UNITED STATES
NUCLEAR REGULATORY COMMISSION
WASHINGTON, D. C. 20555

Docket No. 50-336

LOSS OF DC BUS AT MILLSTONE 2SEQUENCE OF EVENTS

LOSS OF DC BUS AT MILLSTONE 2ANALYSIS AND CONCERNS

FIGURE 1 - SHEET 2 OF 2
SIMPLIFIED ELECTRICAL
SINGLE LINE DIAGRAM
MILLSTONE-2 2/81

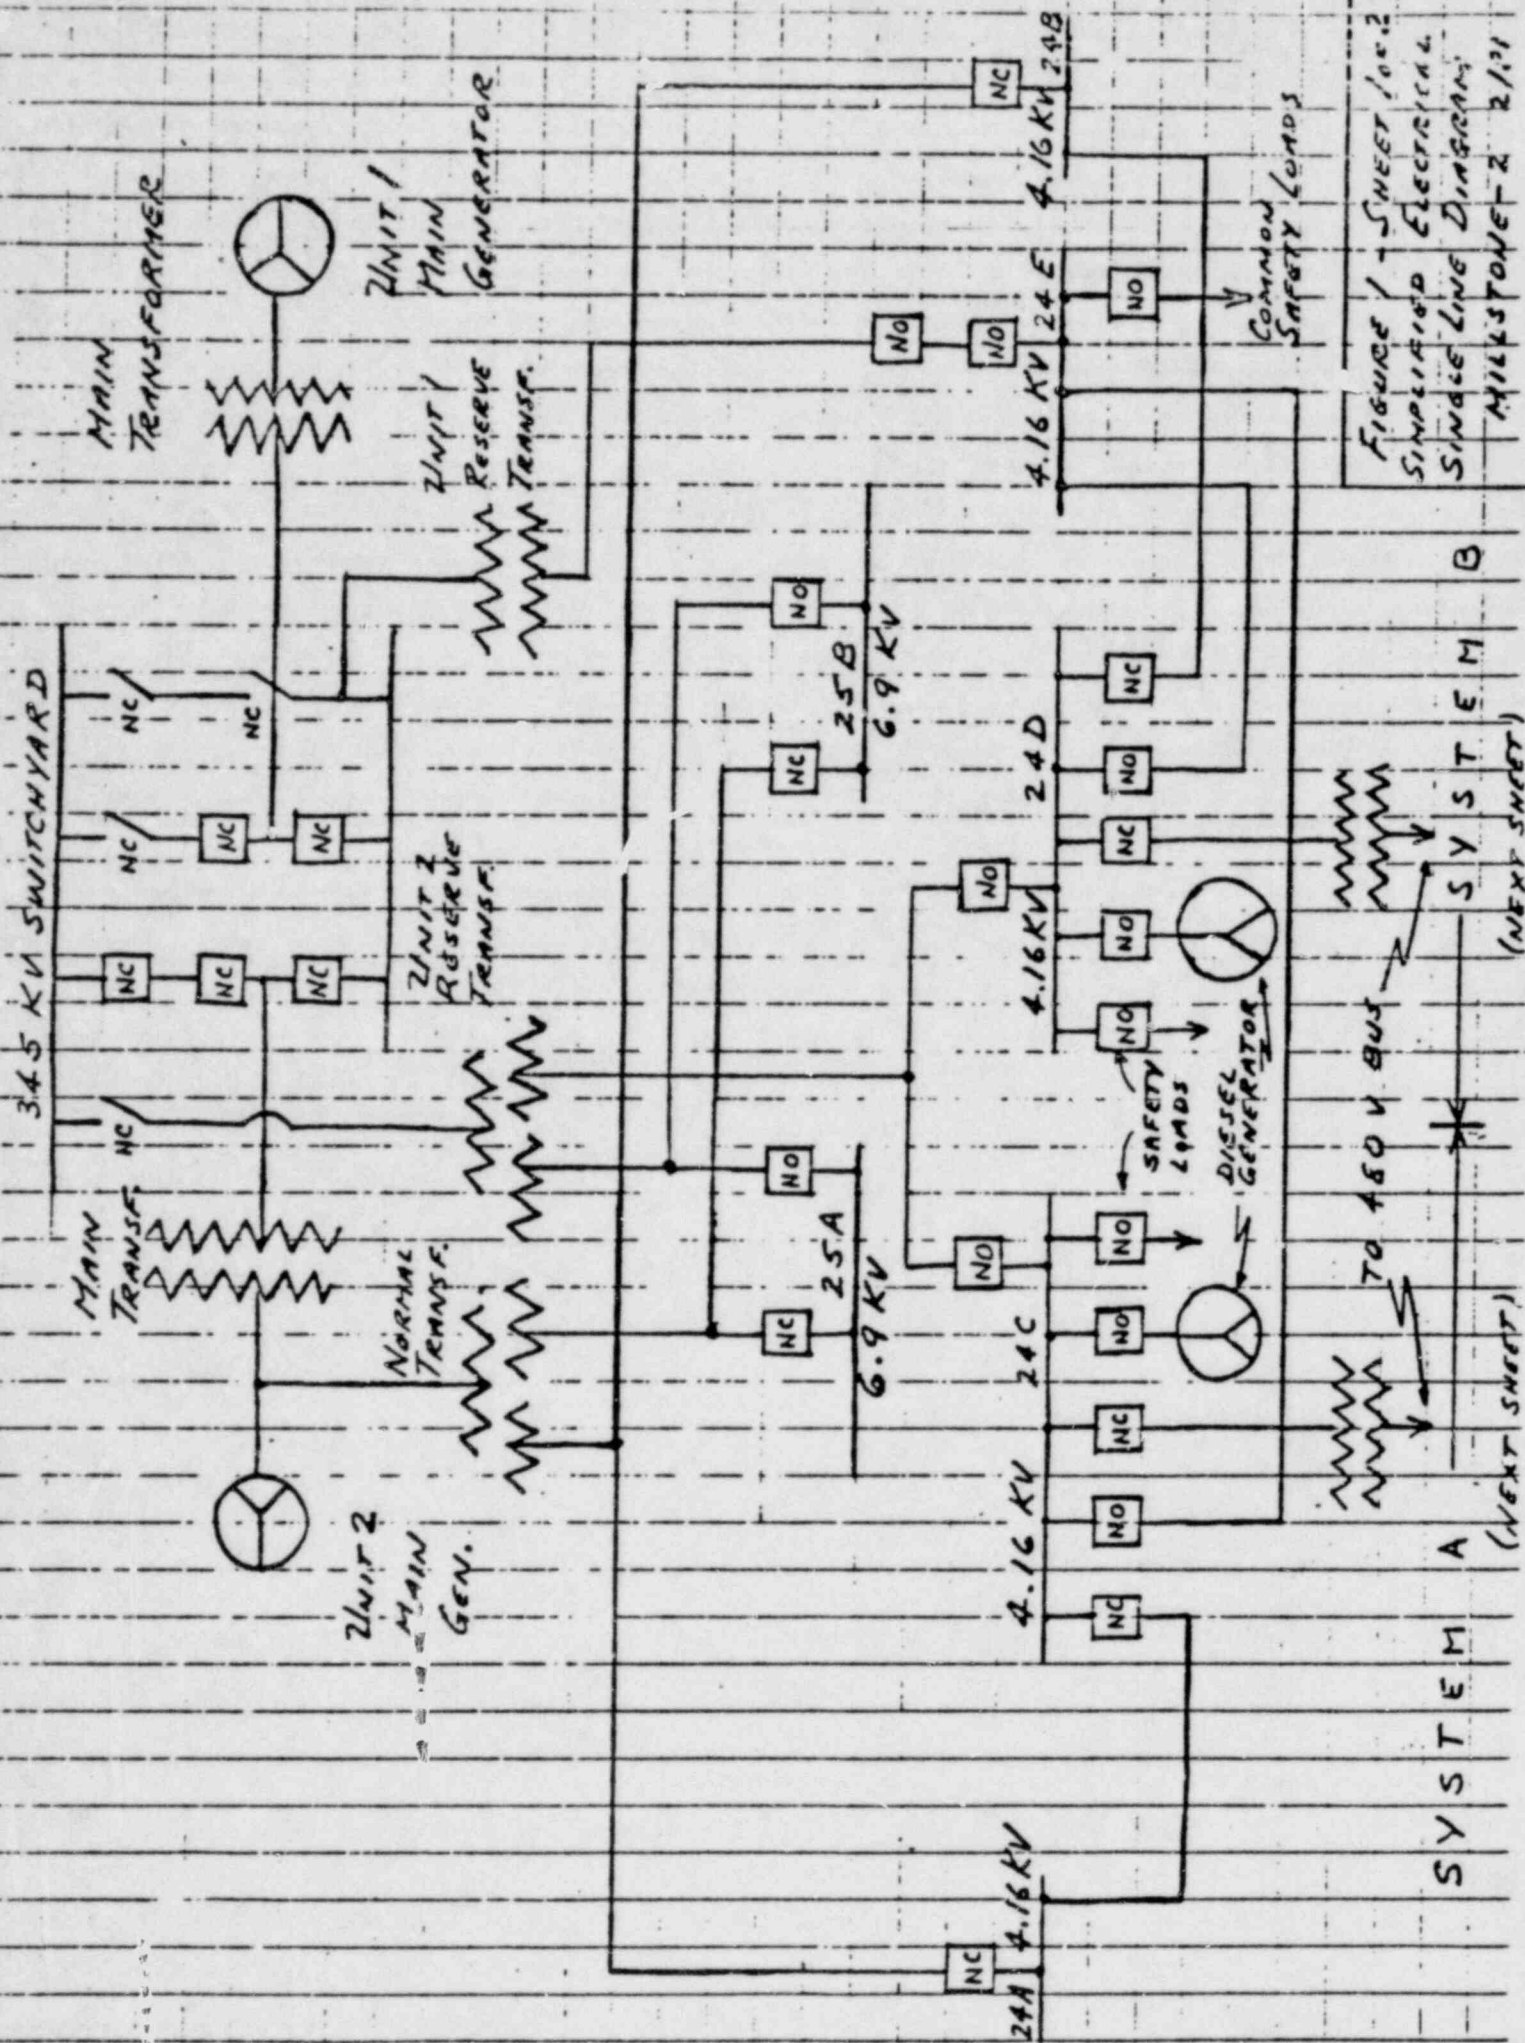
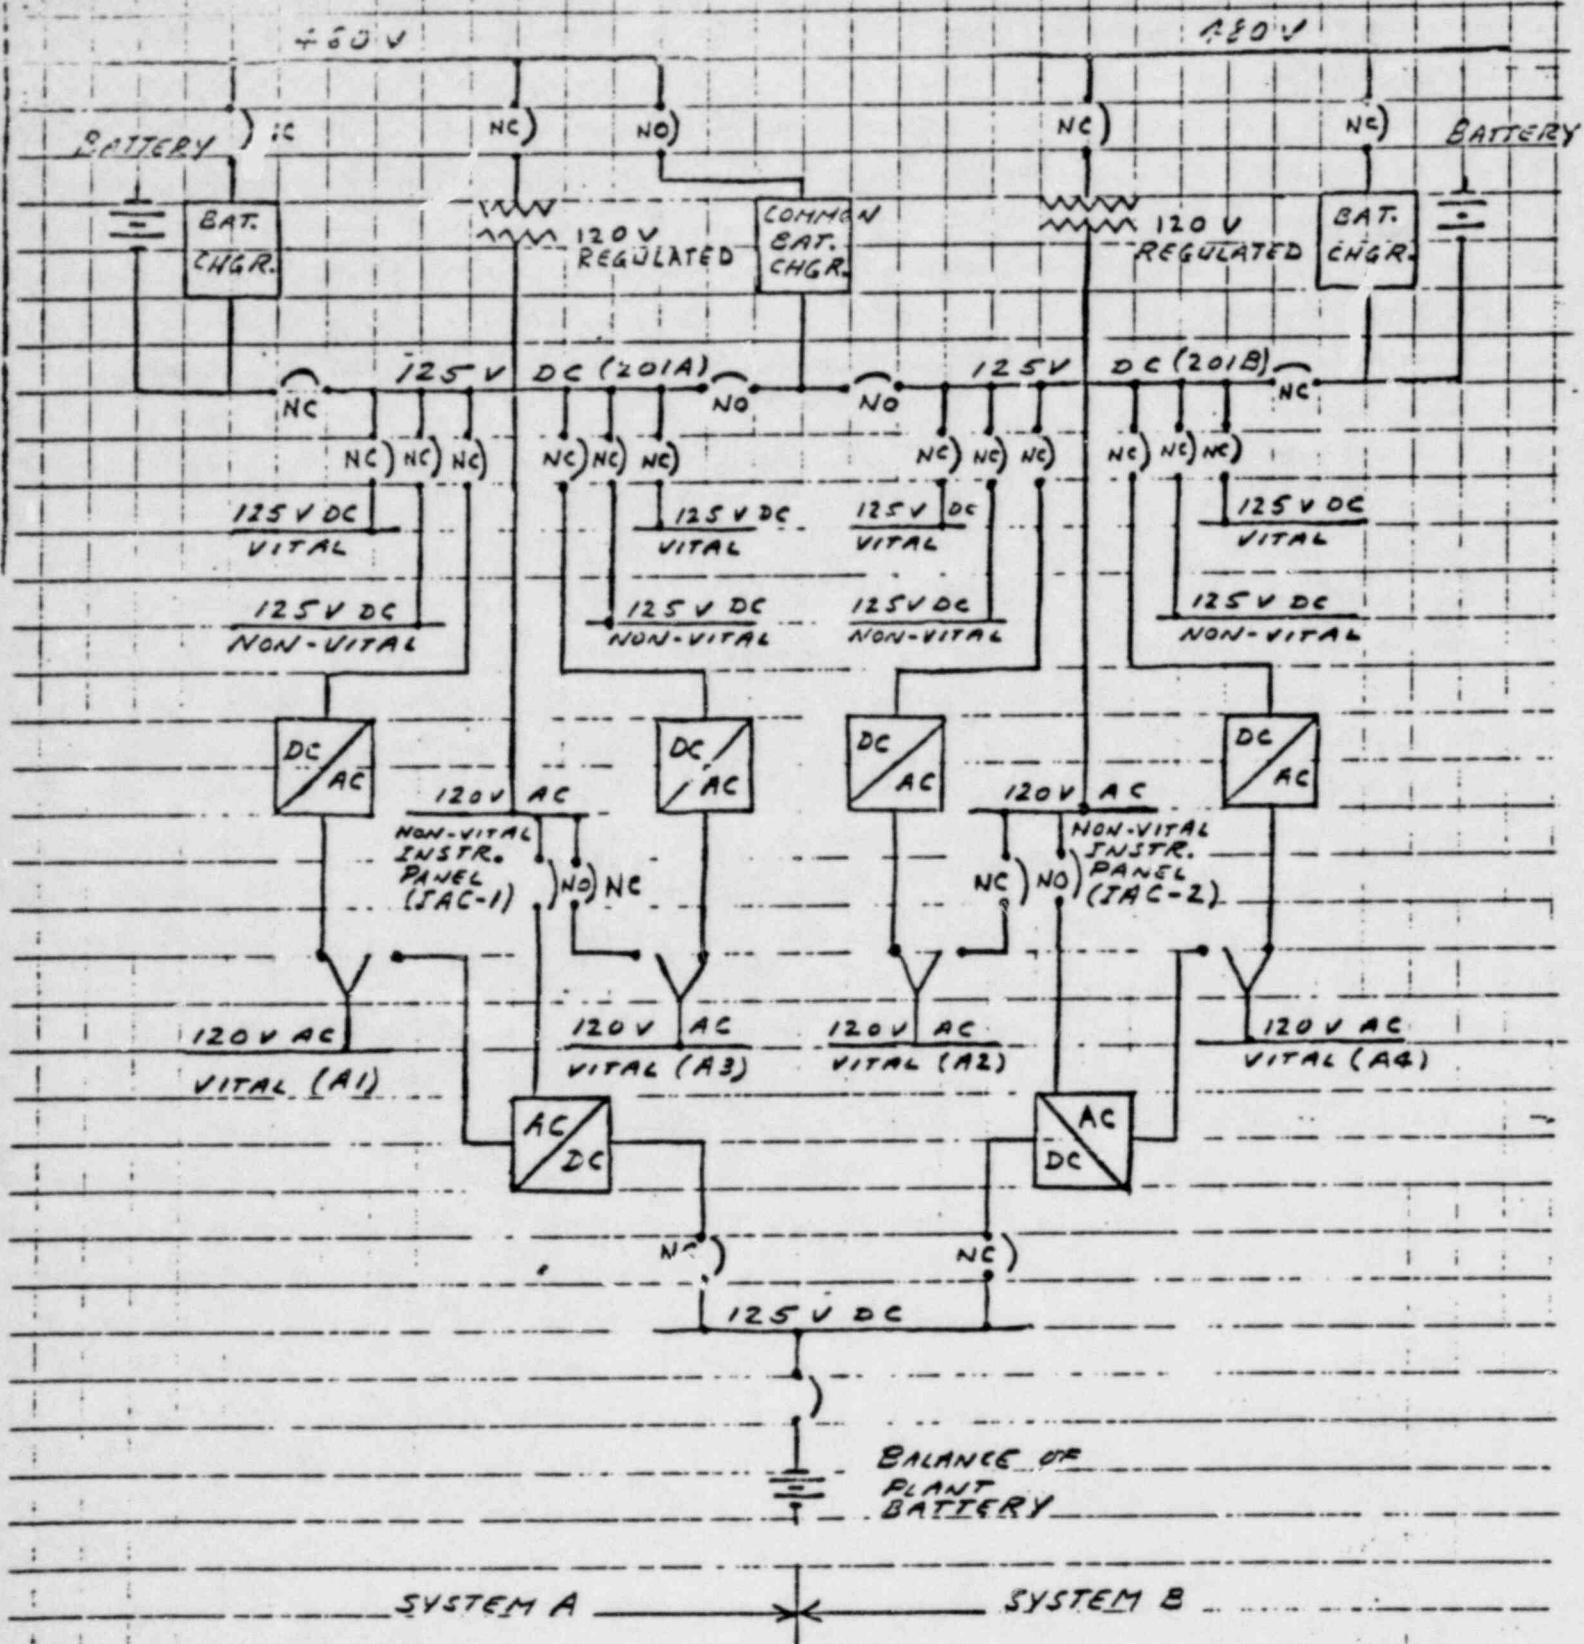
Ten minutes after the initiating event occurred, system B diesel generator experienced a malfunction caused by a water leak which sprayed the speed controller. This resulted in an underspeed condition followed by a low oil pressure trip of the diesel generator. The low oil pressure trip corresponded to an electrical frequency of approximately 45 hertz. At approximately the same time, several fuses were blown in the instrumentation loops being powered from a 120 V ac non-vital instrument panel associated with system B. This panel has been identified in the enclosed Figure 1 as IAC-2.

As a result of evaluating the effects of this event, it was noted that the independence between the two redundant electrical systems could possibly be compromised at the 120 V ac level. As shown in the enclosed Figure 1, each system has two vital 120 V ac buses and one non-vital bus. One vital bus of each system is fed automatically, upon loss of the normal source, from a dc/ac inverter for which the source of dc is the balance of the plant battery (referred as the turbine battery). The other vital bus of each system is fed automatically from the non-vital bus upon the loss of the normal supply. Each non-vital bus can also be supplied from the same dc/ac inverter connected to the balance of the plant battery and used as mentioned before as an automatic alternate source for one of the vital buses. Thus, the design provisions to assure continuity of power to the vital buses from the common balance of the plant battery could also result in the compromising of the required independence between redundant electrical systems.

It is our concern that a single event affecting the non-safety related balance of the plant battery could degrade the battery and/or its associated equipment to a point that could affect the operability of sufficient vital buses in both systems resulting in the loss of protective function when required.

8. Examine the design and recommend modifications (including Technical Specification changes) that will preclude supplying either manually or automatically vital buses in supposedly independent systems from a single non-safety related balance of the plant battery at the same time.
9. Review the design and verify whether the electrical and air aspects of it for each main steam line isolation valve are independent from those associated with its redundant counterpart. If they are not, the licensee must either demonstrate that the safety consequences of an electrical or air related failure disabling both valves are acceptable, or modify the design accordingly. Support the justification of the design with a simplified functional diagram showing the electrical and air interfaces for the main steam line isolation valves.
